**AGENDA
HISTORIC DISTRICT COUNCIL
REGULAR MEETING (VIRTUAL)
JULY 16, 2020
5:00 PM
CITY HALL COMMISSION CHAMBERS
204 ASH STREET
FERNANDINA BEACH, FL 32034**

- 4.2 HDCA 2020-0016: GEORGE MOELLER, 416 N. 3RD STREET**
Amending COA 2018-16 - Changing rear gable siding, modifying a window opening, and replacing foundation infill design. *(Quasi-Judicial)*

MOELLER RESIDENCE
416 N. 3RD STREET
FERNANDINA BEACH
NASSAU COUNTY, FLORIDA

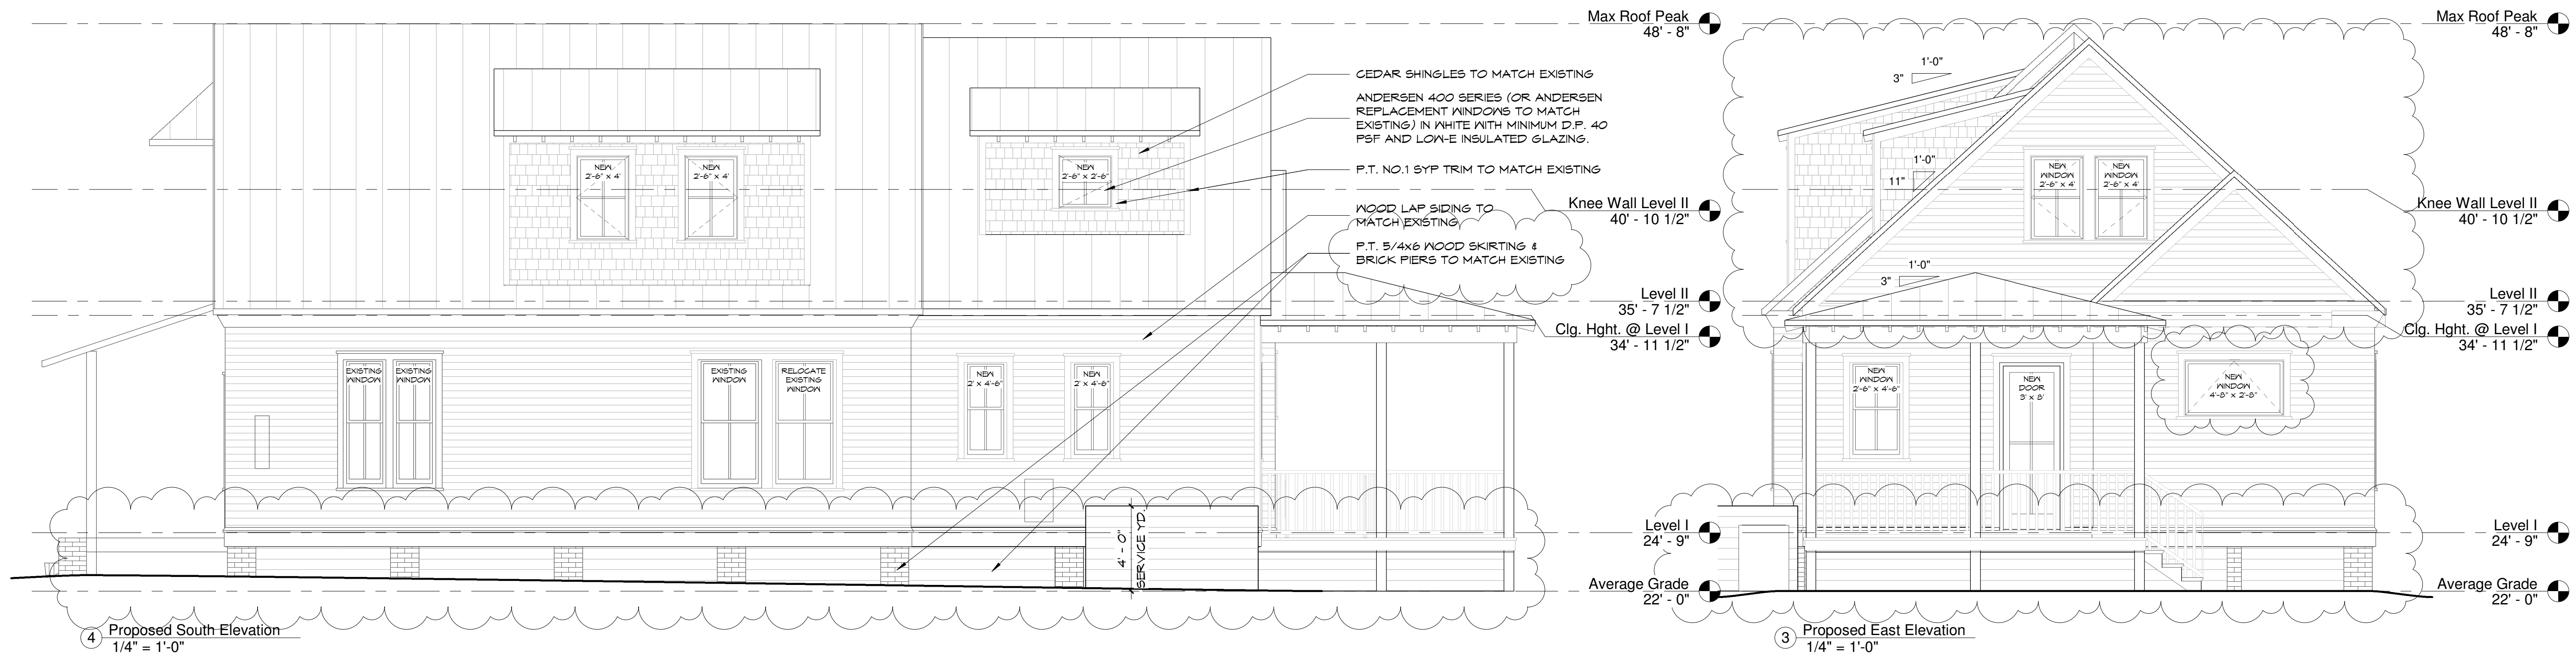
The applicant has made changes to the rear gable siding, lattice design, and modified a window opening. The applicant has requested that we approve the Historic District inspection associated with the building permit absent of paint. Staff ask the board to provide direction as to the acceptable length of time to allow the applicant to finish painting the exterior of the structure.

The change in gable siding material is consistent with the contributing structure's Frame Vernacular style. The change in window openings is on the rear addition approved with COA 2018-26. Downtown Design Guidelines encourage the use of lattice panels between pier foundations. However, the wood skirting that has been added maintains the visibility of the pier foundation.
